THE HILLS SHIRE COUNCIL
3 Columbia Court, Baulkham Hills NSW 2153
PO Box 7064, Baulkham Hills BC 1755
ABN 25 034 494 656 | DX 9966 Norwest

Comments on SSD-78156221 – Mixed-use development with in-fill affordable housing

Council received a request for advice on 25 March 2025 in relation to State Significant Development 78156221 for an Environmental Impact Statement (EIS) for the Mixed-use development with in-fill affordable housing at Cecil Avenue and Roger Avenue, Castle Hill.

Buildings should be named A through to D following the diagram below.

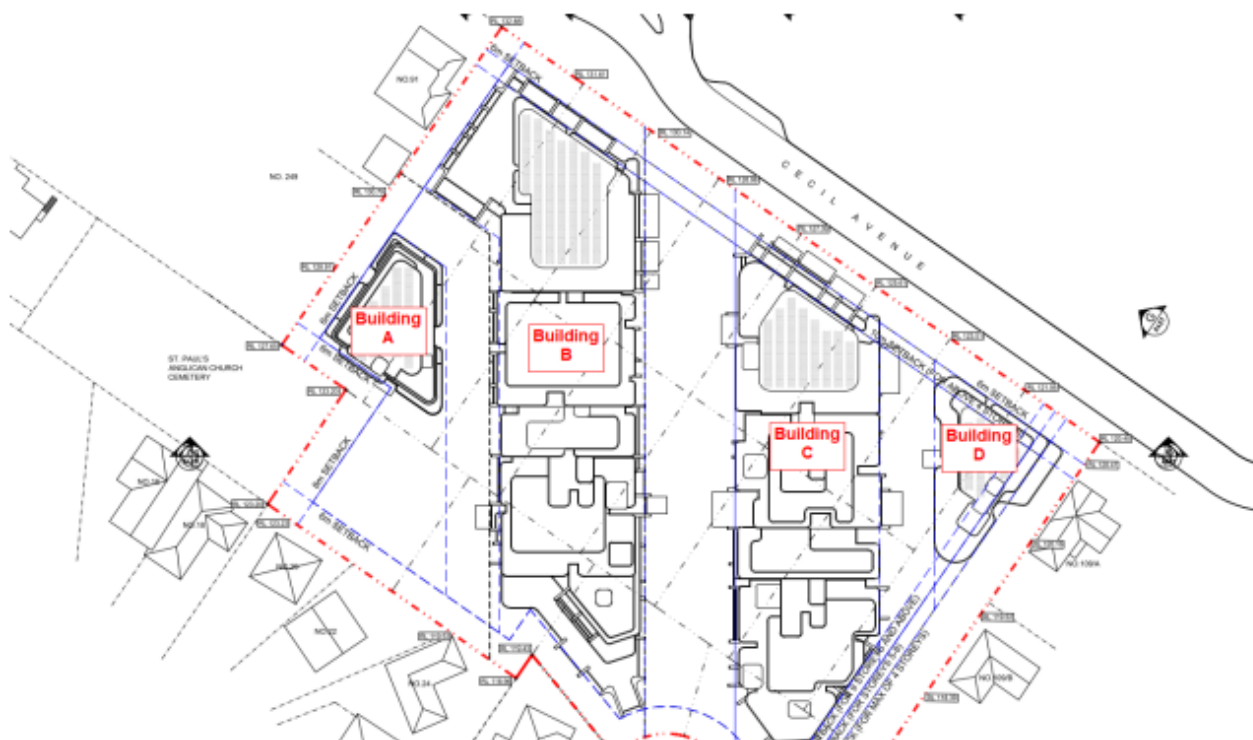
It is noted that there are multiple apartments without entry doors. An example of this on Upper Ground shows an apartment behind the stairwell and along the escape route path. There is no door noted for this apartment, nor would its access point be feasible. All apartments will need access points correctly marked prior to unit numbering taking place.
